Item #10:
Village Trustee Wachs
IL 83 Water System Change Orders

RE: Water System Improvements for IL 83 SSA
ESI Project No. 09-325

**IL 83 Water System:
Change Order #4**

**IL 83 Water System:
Change Order #5**

Long Grove Fire Dept Connection

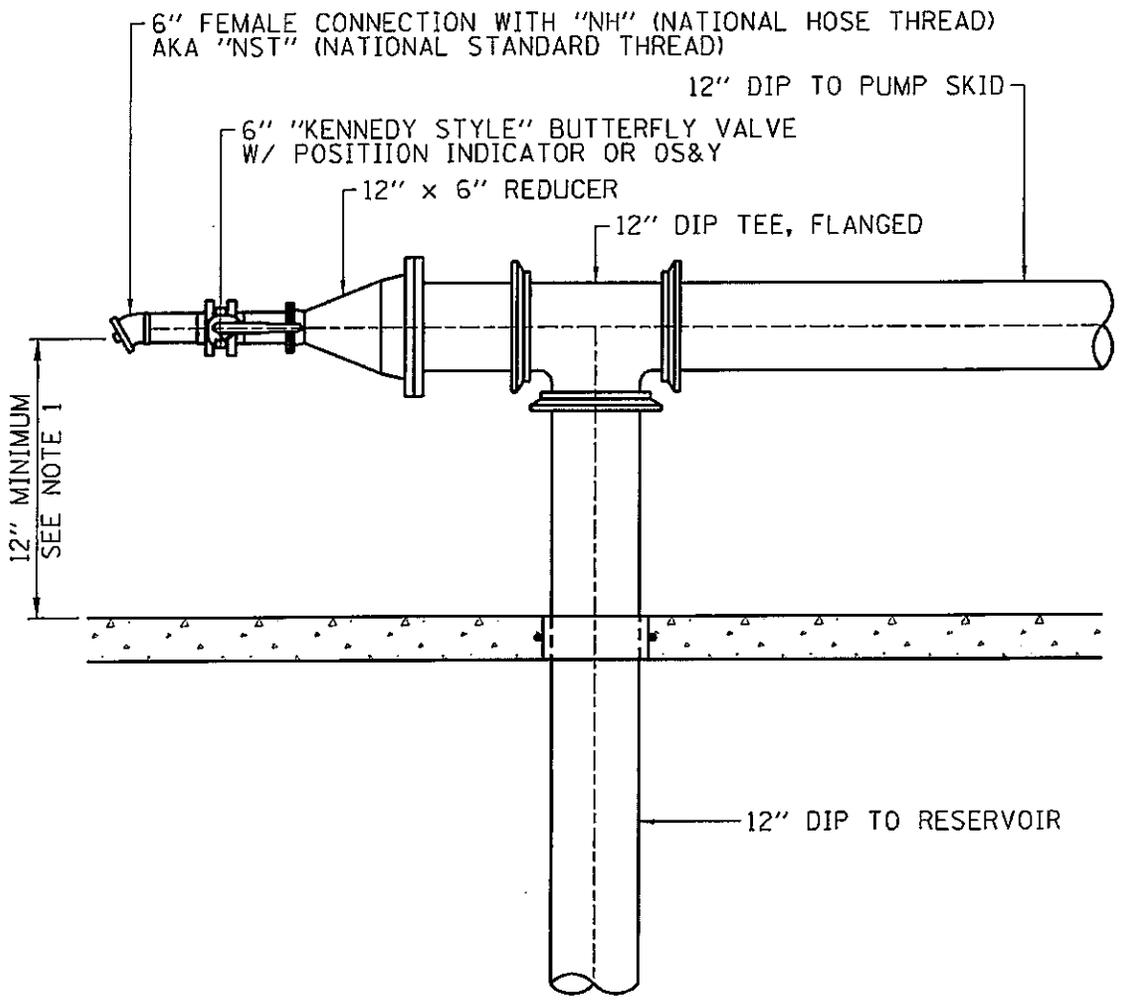
We propose to furnish the necessary labor, material and equipment install a quick connect point for the Long Grove Fire Protection District inside the treatment building, including two bolt down pipe bollards for protection, for the sum of \$4,956.48, broken down as follows:

Work will be done similar to what is detailed on the attached drawing, sheet one, the differences being the addition of two bollards, eliminating the spool pieces, and providing a Dezurich butterfly valve to match the building standard valves. See the attached proposal for additional details.

Attached please find an Itemized breakdown of estimated costs to furnish and install a fire department connection *similar* to the detail provided on the suction side of the booster pump skid at the above-referenced location. Your cost for this work is \$4037.65 (Four Thousand Thirty Seven Dollars and Sixty Five Cents).

As discussed yesterday, we will eliminate as much of the horizontal piping as possible to minimize the length of the installation. Also, we have based our pricing on a Dezurik butterfly valve matching the others installed on the project, not on a "Kennedy style" valve as noted on the sketch.
